**Year 1 Monitoring Report**

**CHAPPELS CREEK MITIGATION PROJECT**

NCDMS Project #100179 (Contract #0402-06)  
DWR Project #2021-0755v2 | RFP #16-20200402

Listed below are comments provided by DMS on January, 17<sup>th</sup> 2024 regarding the Chappels Creek Site: Year 1 Monitoring Report and RES' responses.

**Figure 3A**  
Maintenance Completed  
MY1 2023

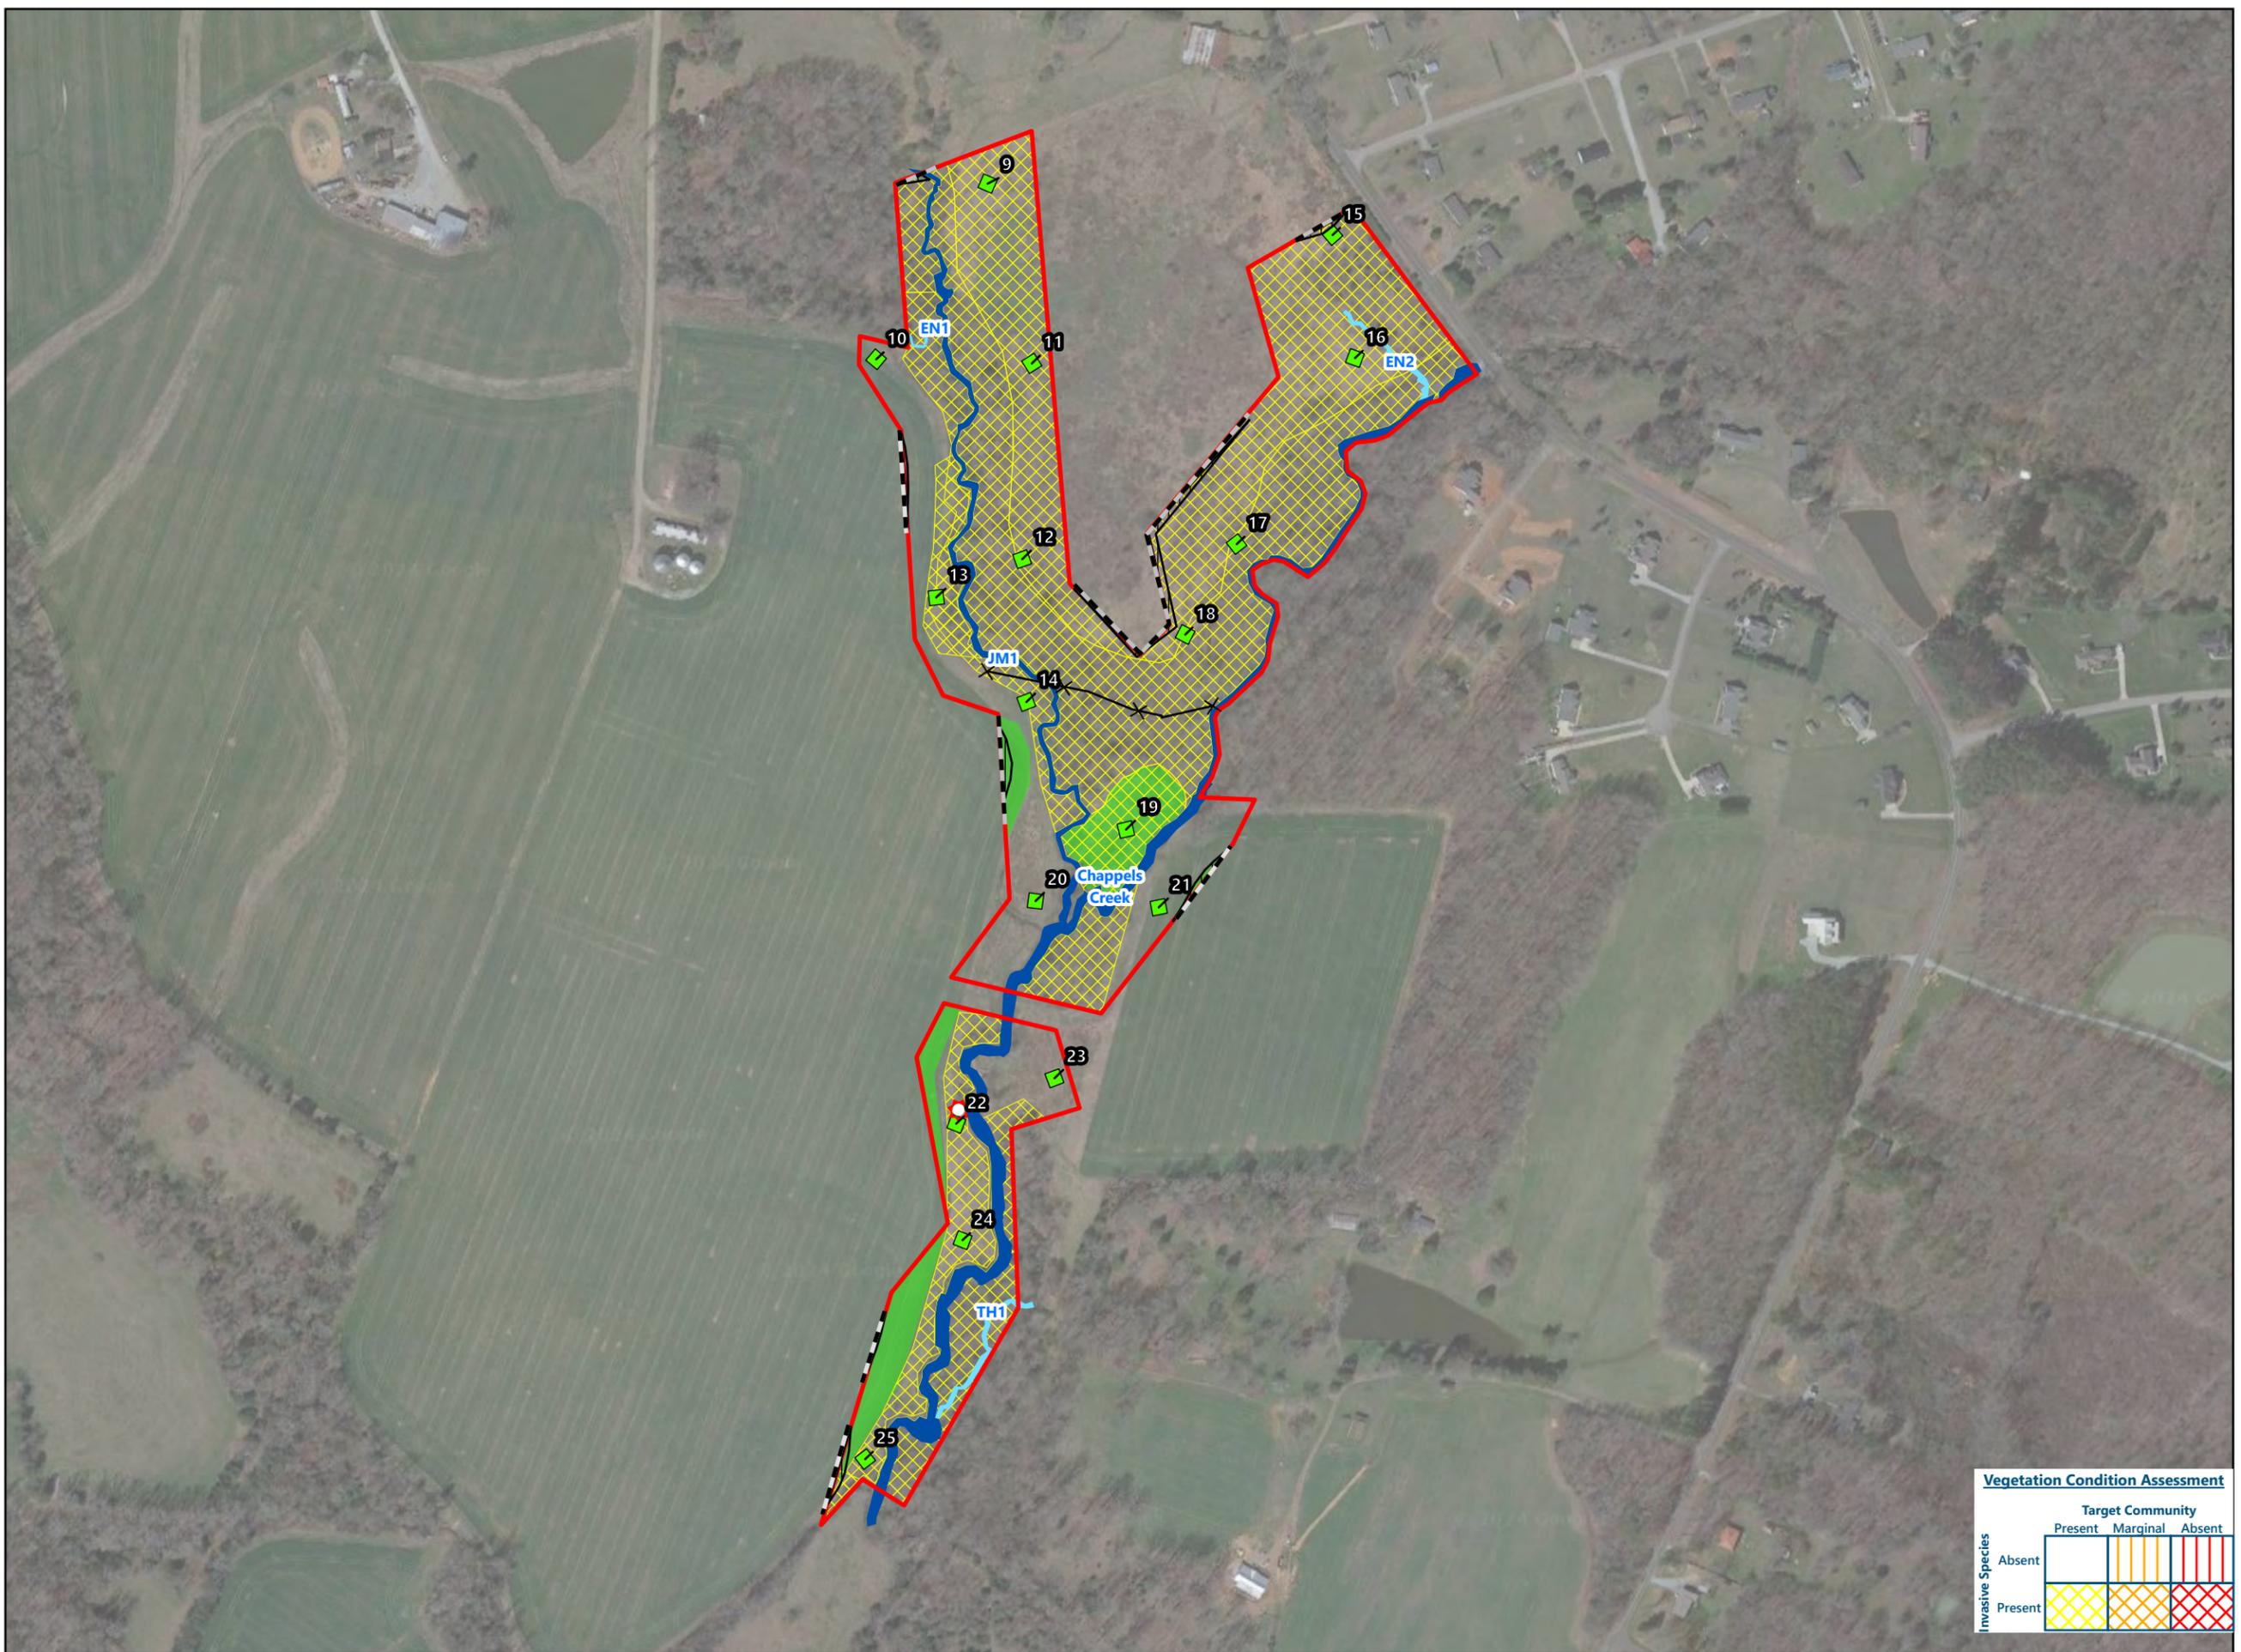
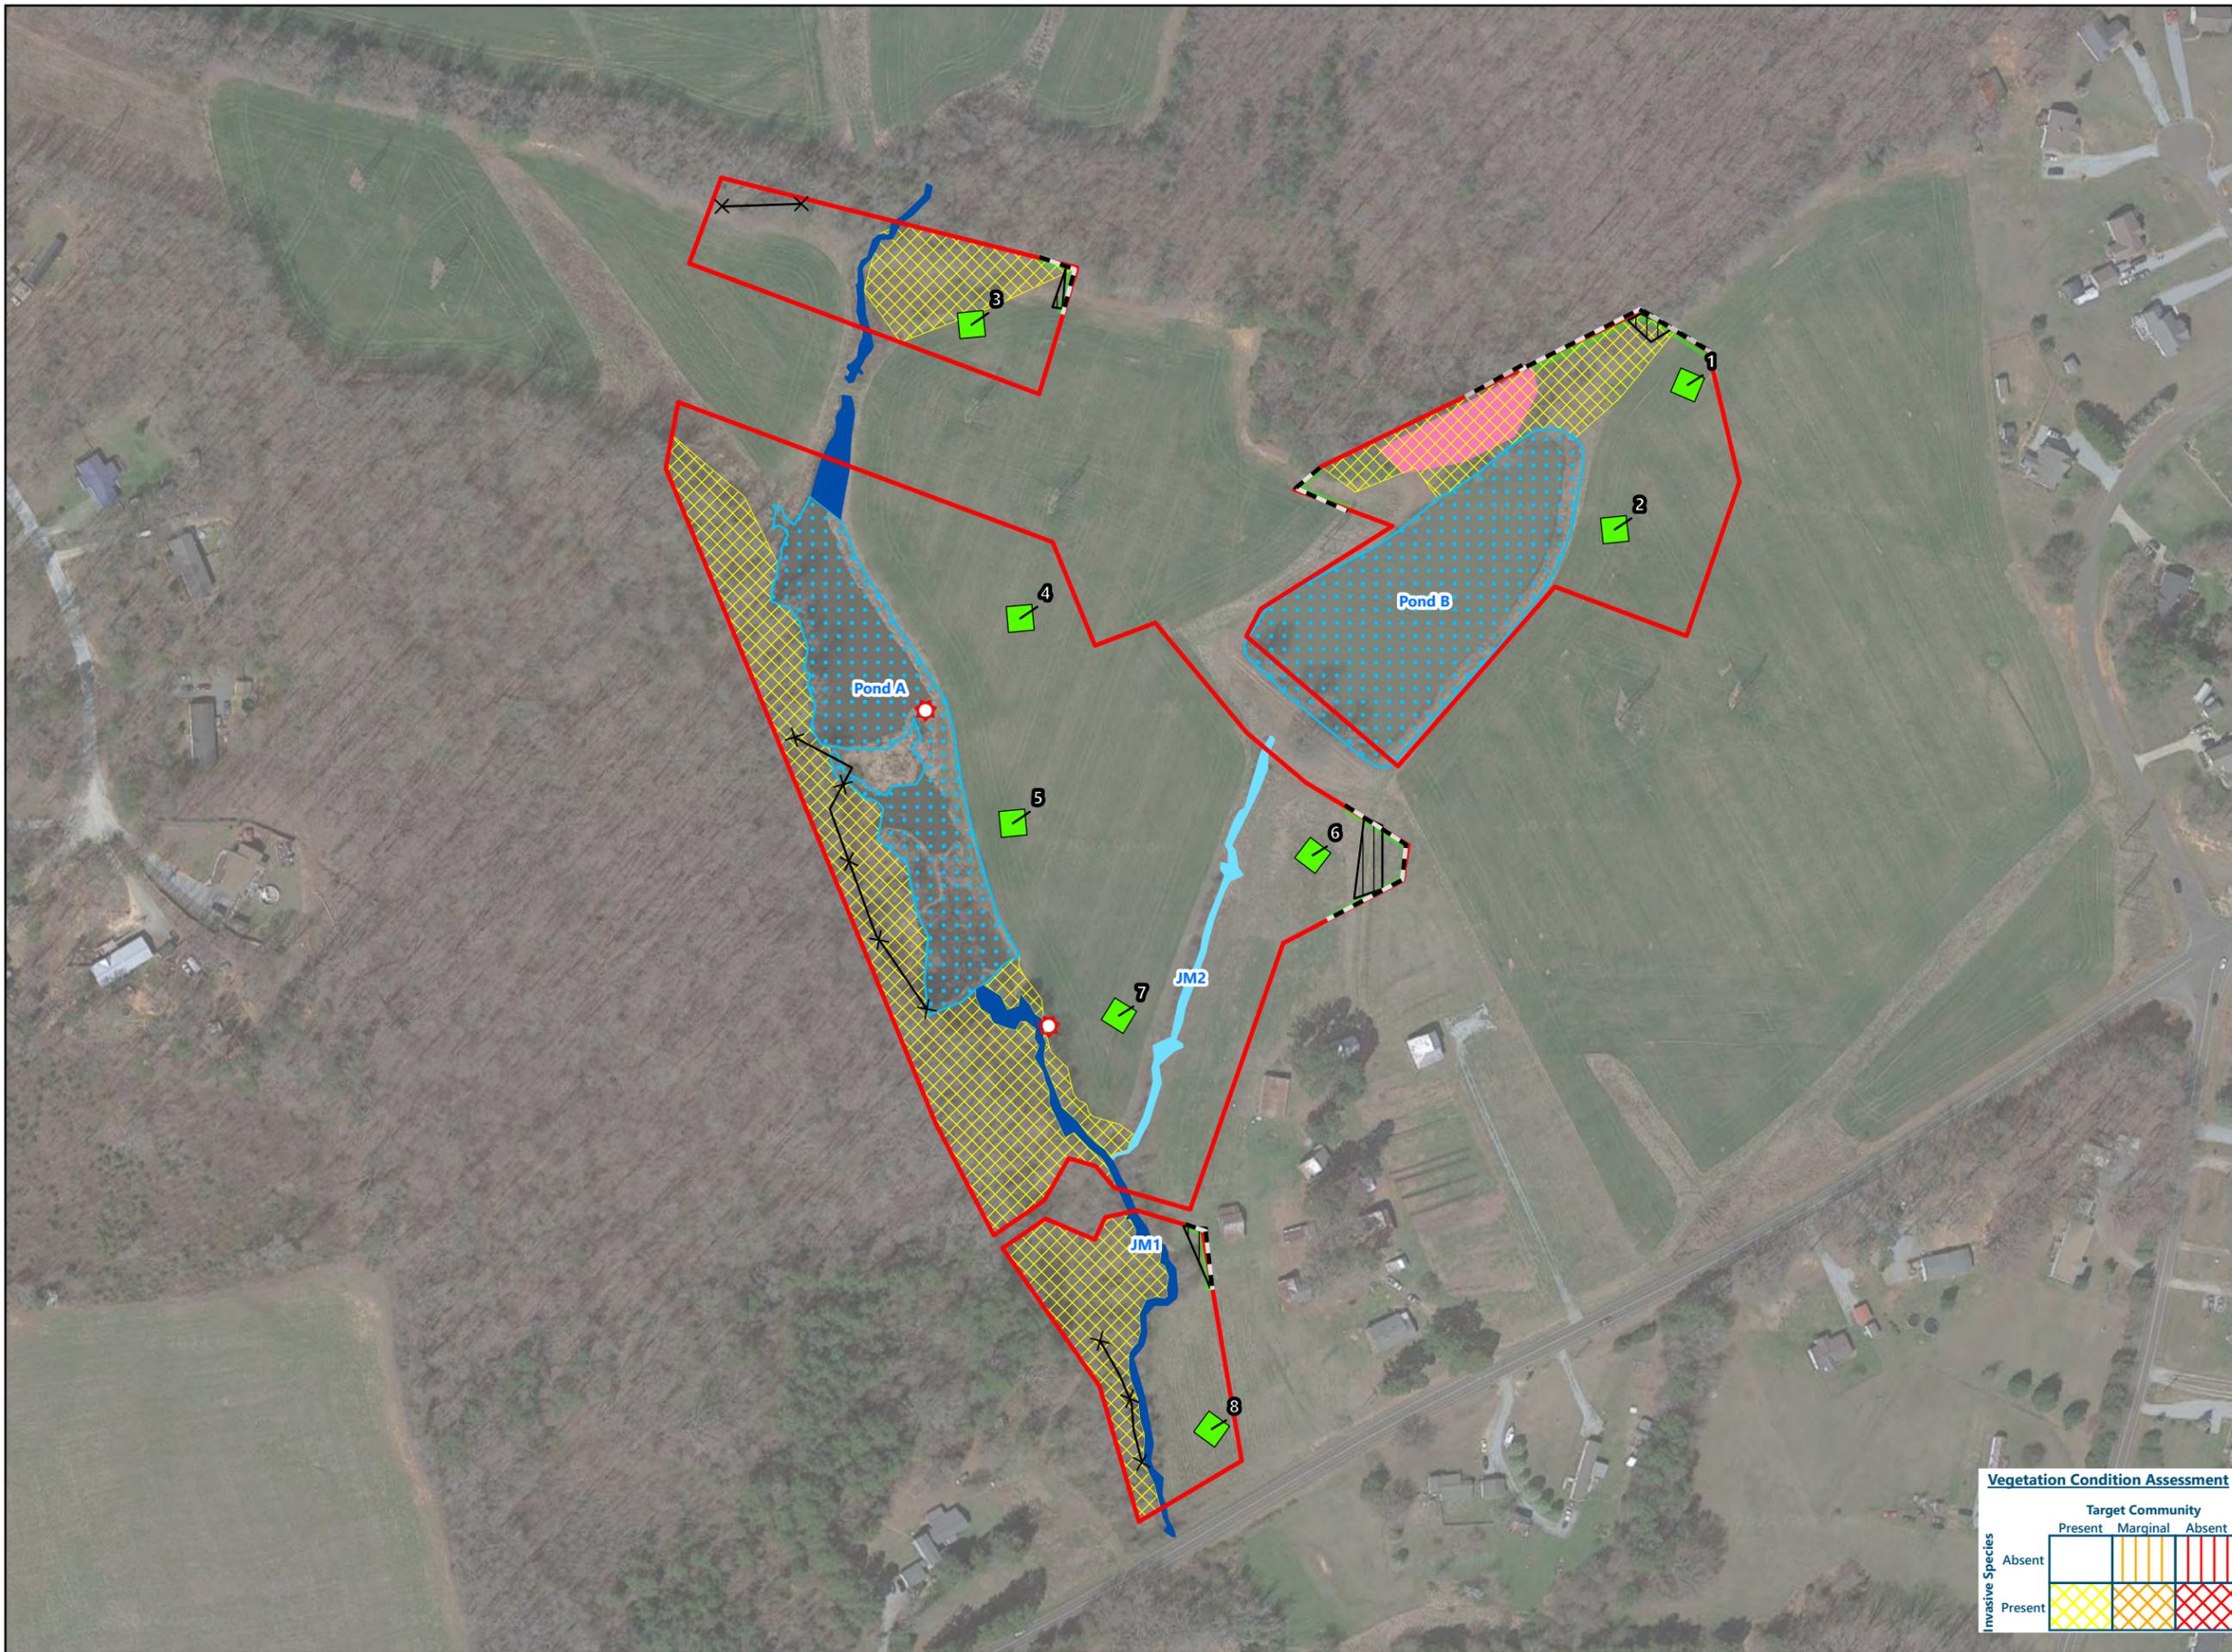
3. Section 4.4: Review of the photos and Figure 4A indicate the area surrounding veg plot 19 was supplementally planted. Please include details for this supplemental planting (why it was needed, survey data to support need, etc.).

6. Appendix A, Figure 4A and 4B: Please label the streams/ponds.  
Streams and ponds are now labeled.

7. Appendix A, Figure 4A and 4B: Please include all encroachments on these figures and submit a shapefile of the encroachments in the digital submittal.  
Encroachment areas have been shown on the maintenance map and the shapefile has been included in the digital submission.

[The following statement has been added to Section 4.4 "Included within the supplemental planting was the area surrounding VP 19 which needed supplemental planting due to extensive box elder treatment within the vicinity. Due to the nuisance species outcompeting the planted stems as well as treatments towards the box elder causing higher mortality to the initial planting supplemental planting took place in the area."](#)
